Model		NA2 (European & Taiwan versions only)						Volt/Hz	Date of Modification	Serial Number		
Modified Article												
Reason for Modification		To prevent thin white lines										
Draw No.	Old Parts No.		New Parts No.	Description	A.B.C.	Q'ty Used		Inter-change-ability	Part needed for replacement by new part		Parts Catalog	
					Rank	Old	New		Part No.	Description	Index No.	Page
	C2098151			Flat Cable - Main / IPB - 75mm		1	0					
			C2108420	Flat Cable - Main / IPB - 110/220/240V		0	1	X/O			16	85

DETAILS OF MODIFICATION

Model	NA2	Volt/Hz	Date of Modification	Serial Number
Modified Article	Main Board ROM for 4 Languages			
Reason for Modification	At the field's request

Drawing No. 1

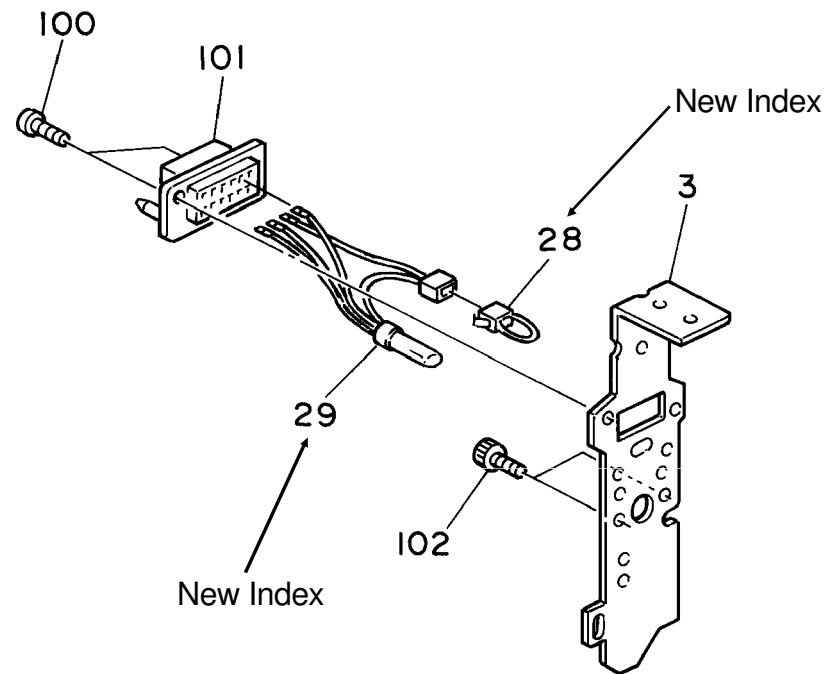
1. Add two parts and index numbers in the illustration as shown in Drawing No.1

NRG/Ricoh	Index	Part Number	Description	Q'ty
Common	14	C5284900	Rear Drum Frame & A4 Cam Ass'y	1
Common	18	C5284851	Teflon Screen - A4/LT Drum	1
Common	23	C5274549	Screen Plate Spring - A4/LT Drum	2
Common	* 28	C5288173	Short Connector - A4/LT Color Indication	1 (See Drawing No. 1)
Common	* 29	C5288172	Relay Harness - A4/LT Drum	1 (See Drawing No. 1)

Drawing No. 2 (Page 62)

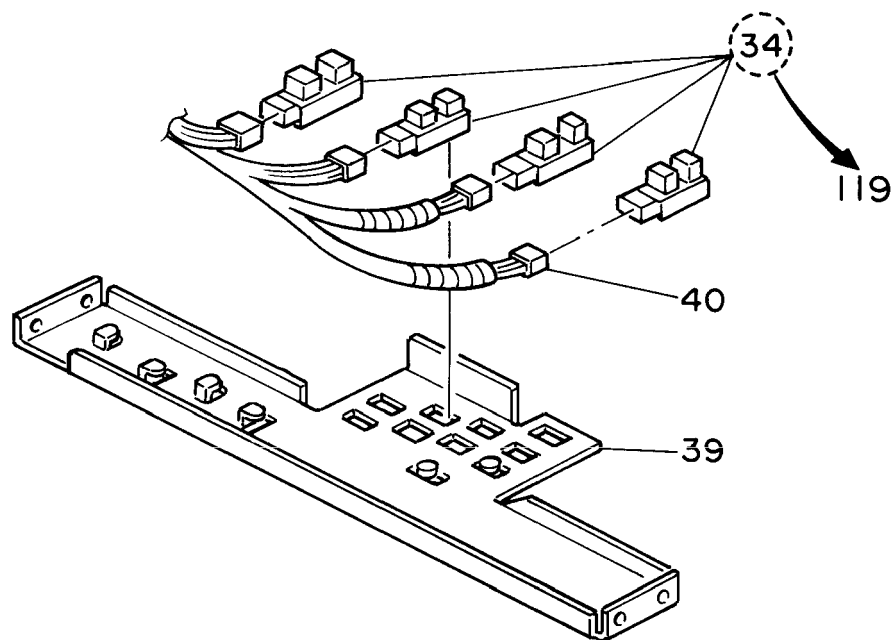
1. Correct a index number in the illustration as shown in Drawing No. 2.

NRG/Ricoh	Index	Part Number	Description
NRG	* 119	14030690	Photointerrupter (See Drawing No. 2)

Drawing No. 3 (Page 82)

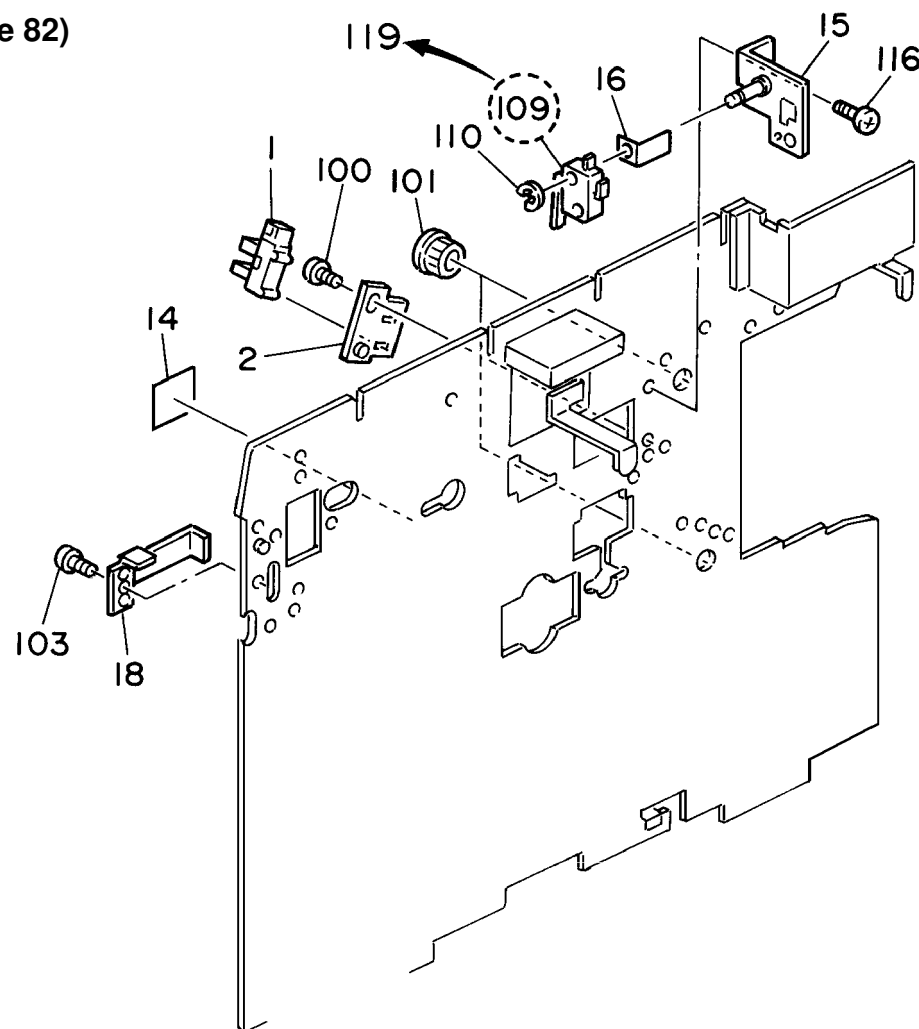
1. Correct a index number in the illustration as shown in Drawing No. 3. (NRG version only)

NRG/Ricoh	Index	Part Number	Description
NRG	* 119	12041442	Microswitch (For all version machines)

Drawing No. 4 (Page 84)

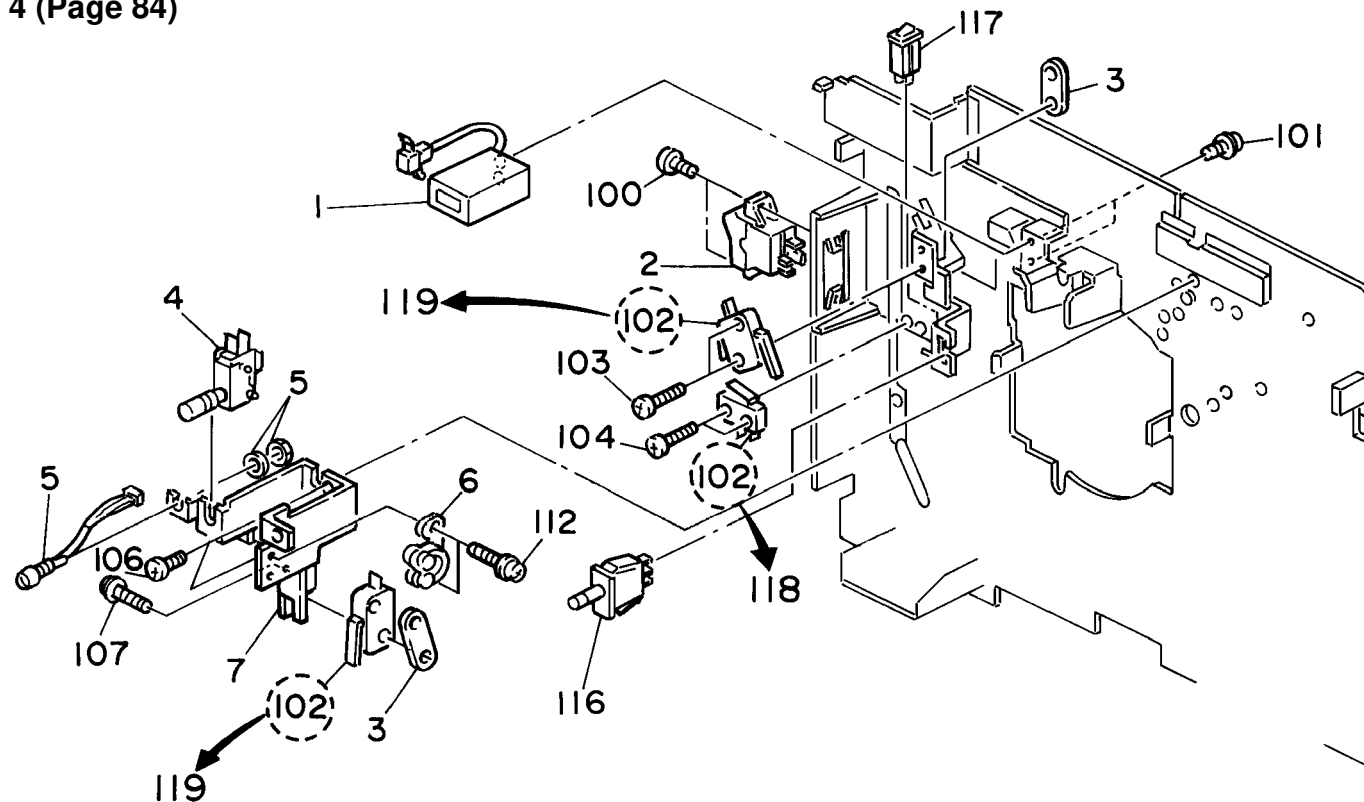
1. Correct index numbers in the illustration as shown in Drawing No. 4.

NRG/Ricoh	Index	Part Number	Description
Ricoh	117	11070707	Circuit Braker - 5A 250V (220/240V)
Common	* 118	12042239	Microswitch
Common	* 119	12041442	Microswitch

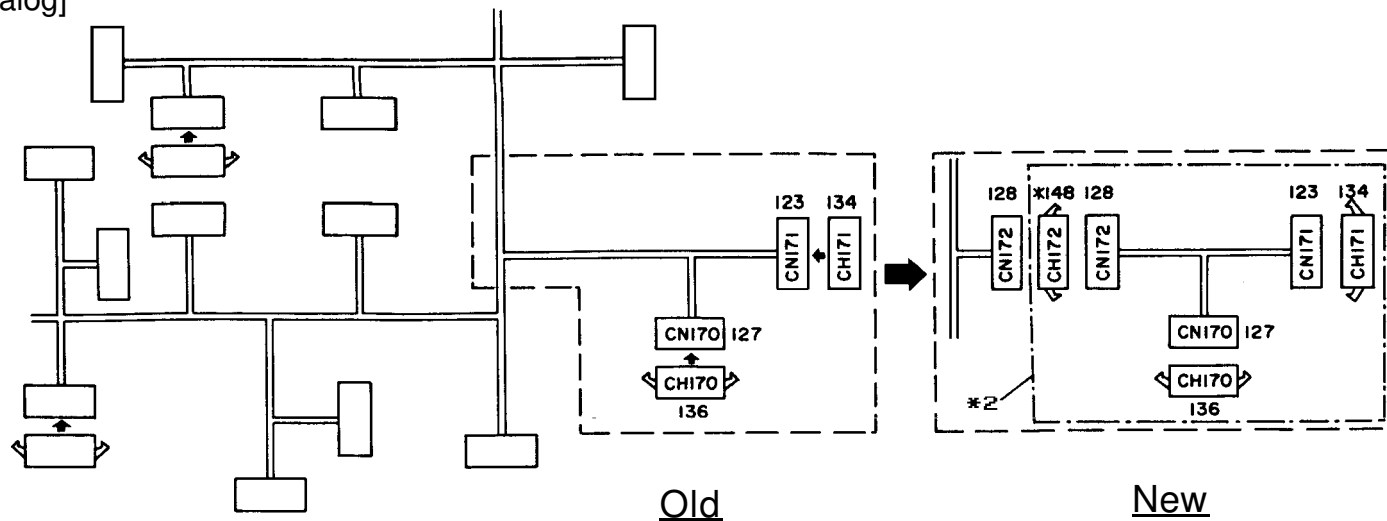
When removing the paper feed front plate, it is necessary to disconnect two harness for the paper re turn motor and separation plate pressure release solenoid. To facilitate servicing at that time, the DC drive harness has been changed. Now the connector (CN172) can be disconnected near the paper feed front plate.

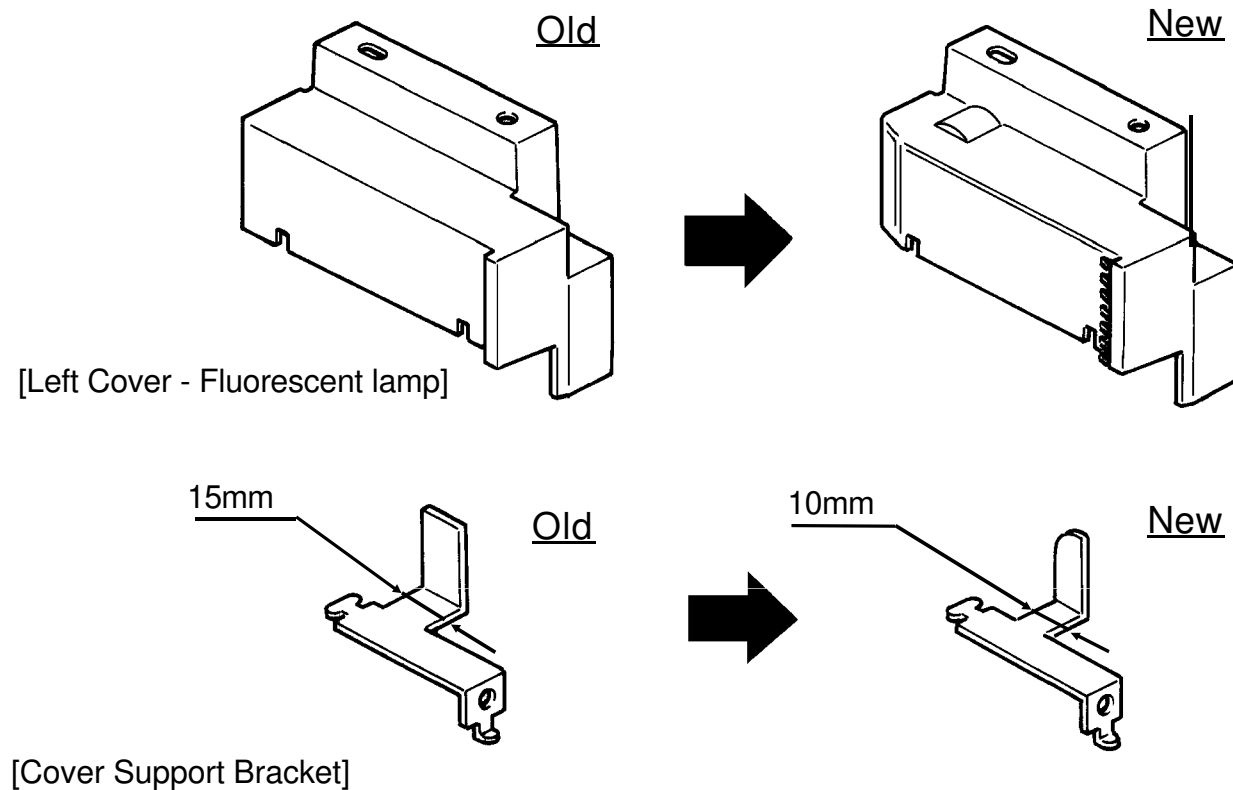
The left and right fluorescent lamp covers have been changed so that an operator can grip them easily when opening the scanner unit. For the right cover, the improvement is minor and the part number has not been changed (# C2103219 for NRG USA/TAIWAN version, # C2103220 for NRG European version, # C2103223 for Ricoh version). However, the left fluorescent lamp cover has to be replaced with the cover support bracket (# C2093169) at the same time, so its part number has been changed as described on the first page.

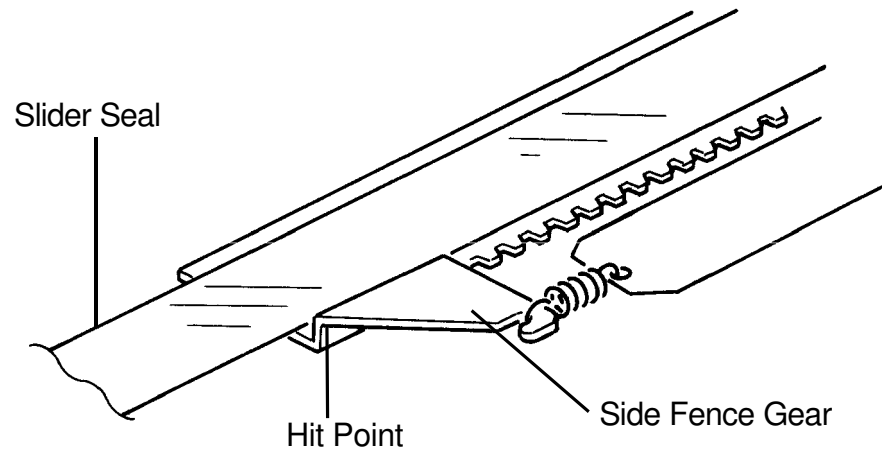
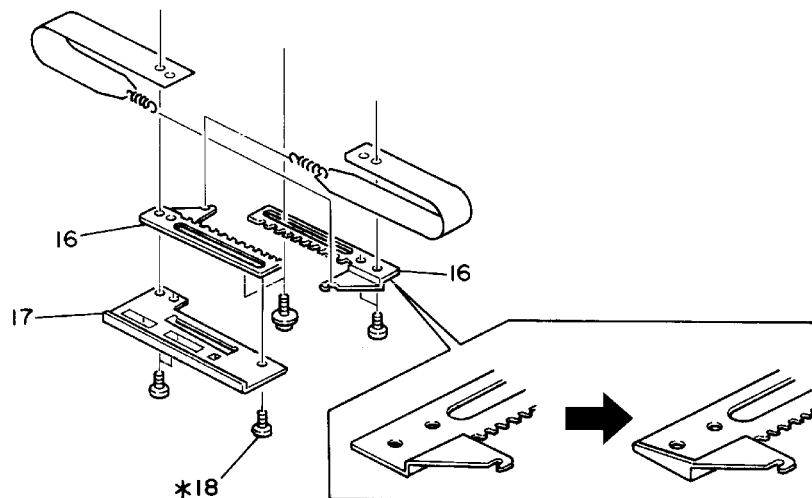
When an operator moves the original side guides to adjust them to the original width, the slider seals (mylar strips : C2093093) tend to be caught by the edge of the side fence gears (See figure). This may cause the operation of the original side guides to be hard.

To make the original guides move smoother, the shape of the side fence gears has been changed as shown in the below figure. At the same time, the sensor shielding plate (Index 17) has been secured with the side fence gears by a screw (Index 18) in order to remove play.

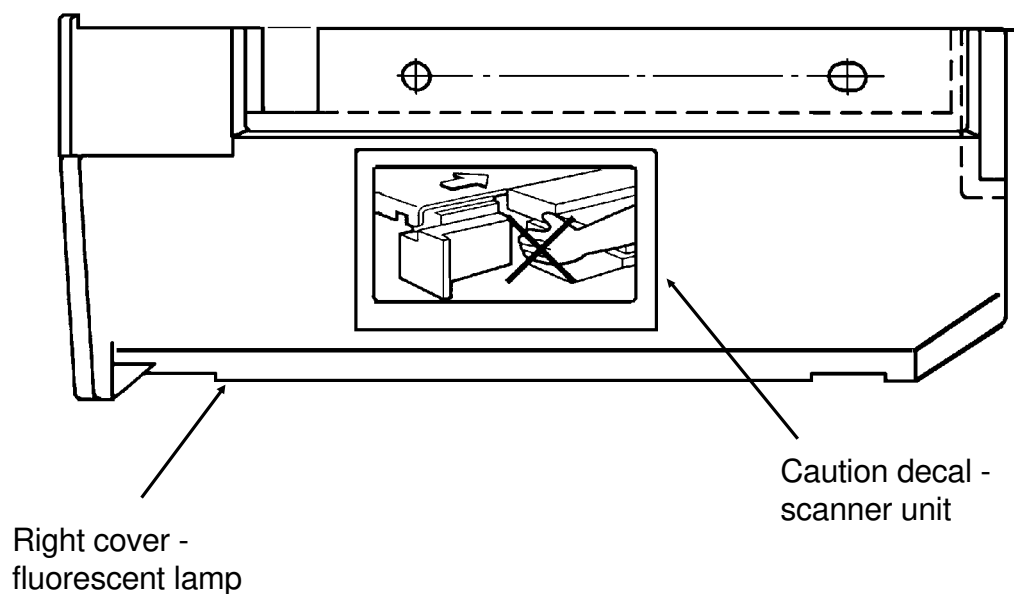
A caution decal is added to the right fluorescent lamp cover to tell to the customers not to catch their hands between the scanner unit and the main body.

Illustration 1

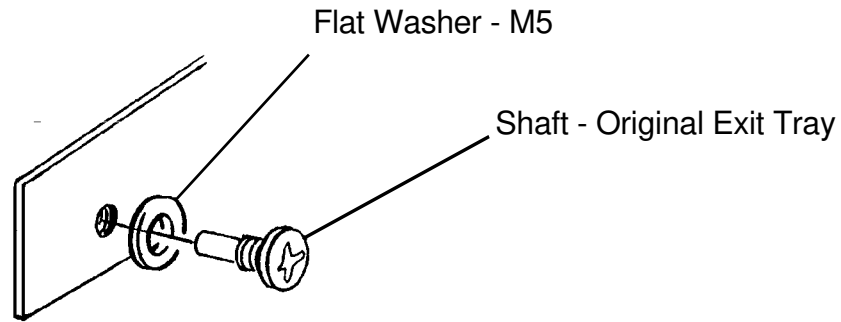
To prevent the original tray fixing nut from becoming loose, original tray shafts have been modified . Screw holes are made on the side plates and the shafts are screwed tightly with the washer in the factory. (illustration 1.)

Illustration 2

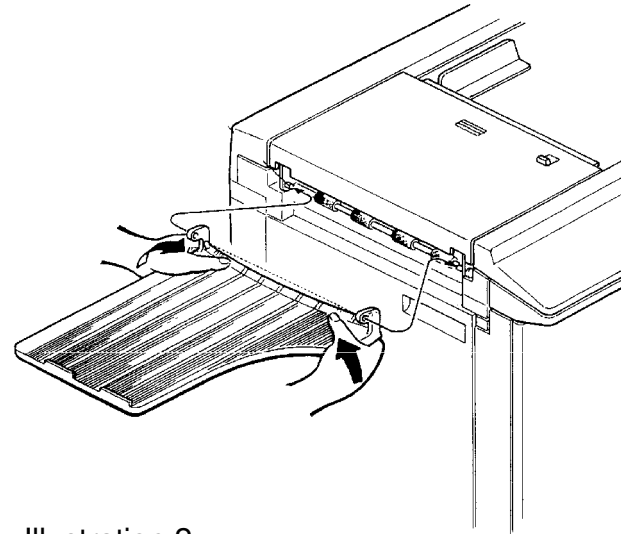
Due to this modification, installation procedure has been changed. To install, bend in the original exit tray slightly, placing the shaft through the holes provided on the original tray as in illustration 2.

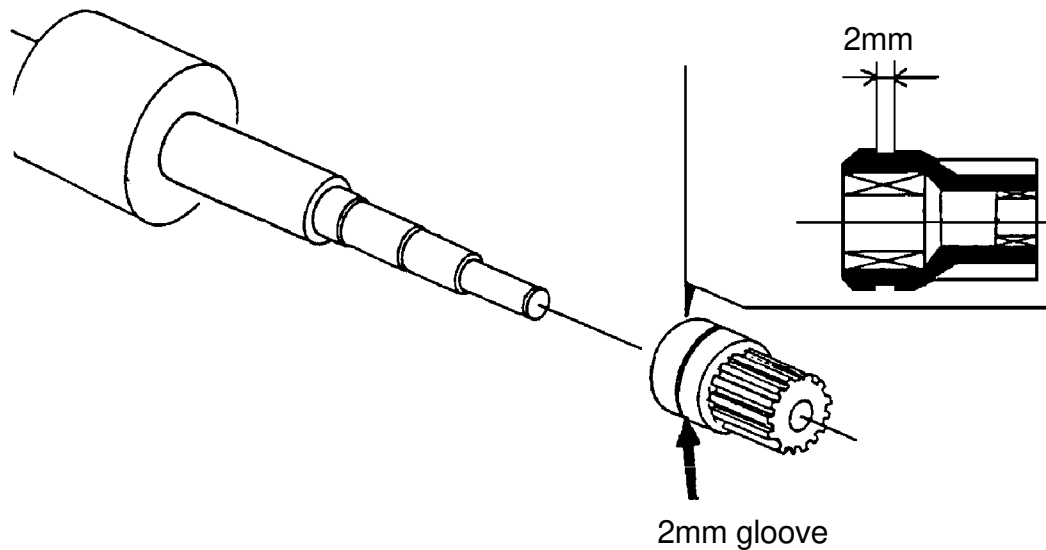
To increase reliability of the feed roller clutch, the grease enclosed in the feed gear clutch has been changed. To distinguish the new gear from the old gear visually, the new gear has a 2mm groove on its surface.

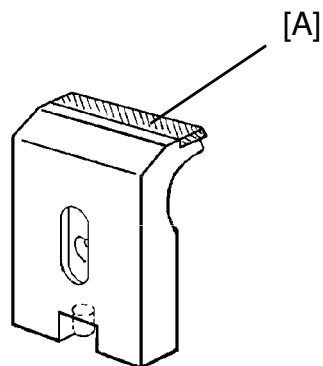
To increase durability, the material of the separation plate pad [A] has been changed. The color of the pad has been changed from black to white.

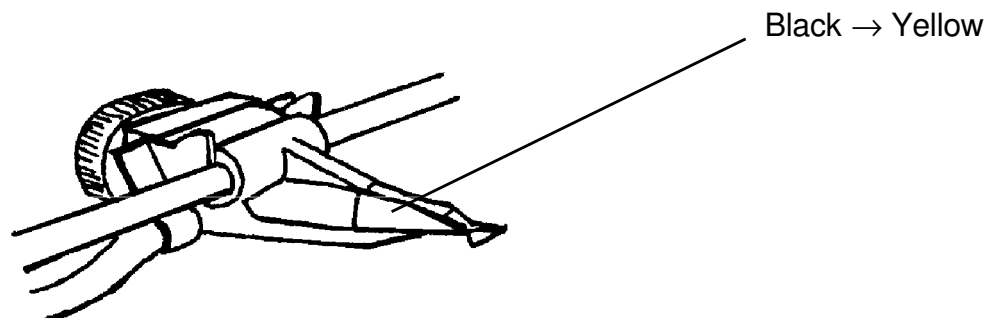
The tip of the exit pawl is sharp and it is possible for a customer to get hurt by the pawl when removing jammed paper. The exit pawl color has been changed from black to yellow to make it more visible.

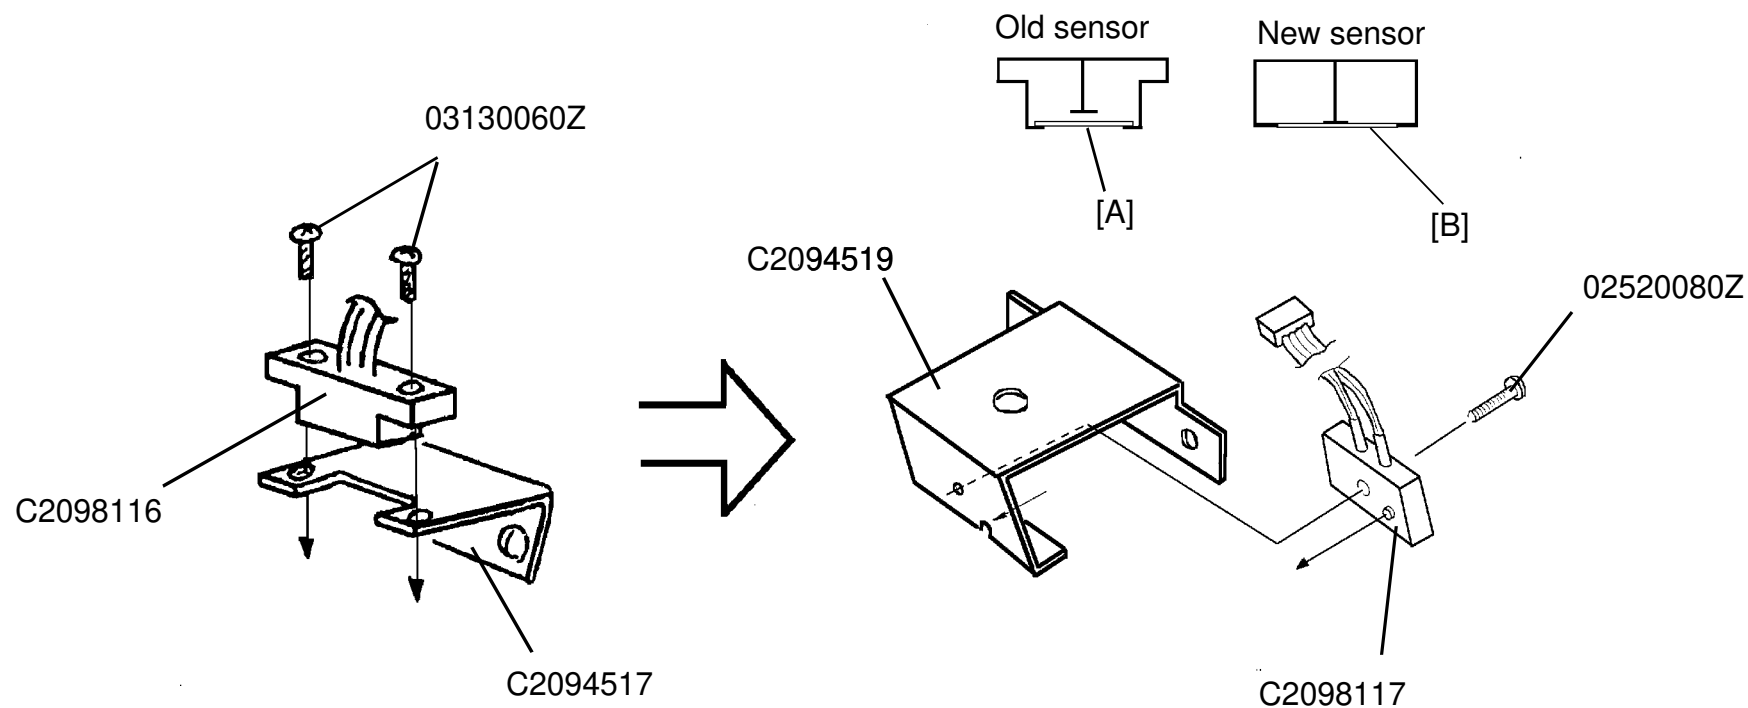
It is sometimes reported that the drum master detection sensor does not detect the master on the drum. This problem happened when the filter [A] was out of position. To prevent this, the drum master detection sensor has been modified. The filter [B] of the new sensor is fixed in position.

Due to this modification, the shape of the drum sensor bracket has also been changed as shown in the illustration.

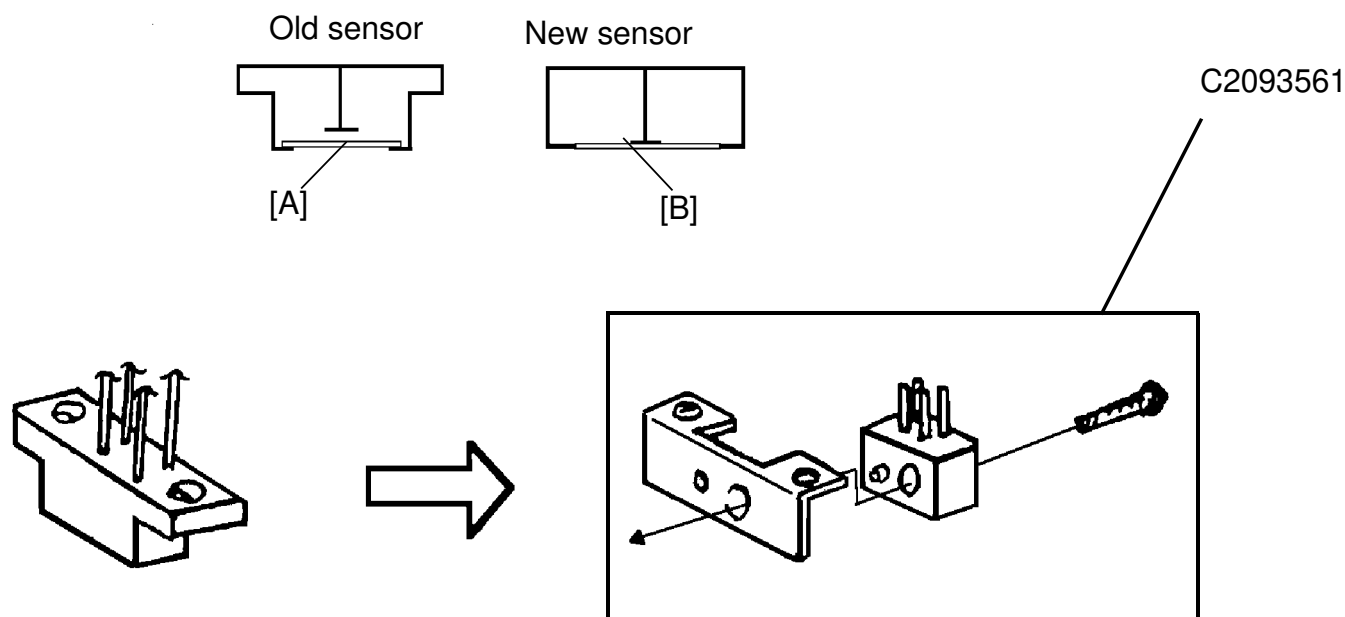
It is sometimes reported that the master eject sensor does not detect the ejected master. This problem happened when the filter [A] was out of position. To prevent this, the drum master detection sensor has been modified. The filter [B] of the new sensor is fixed in position.
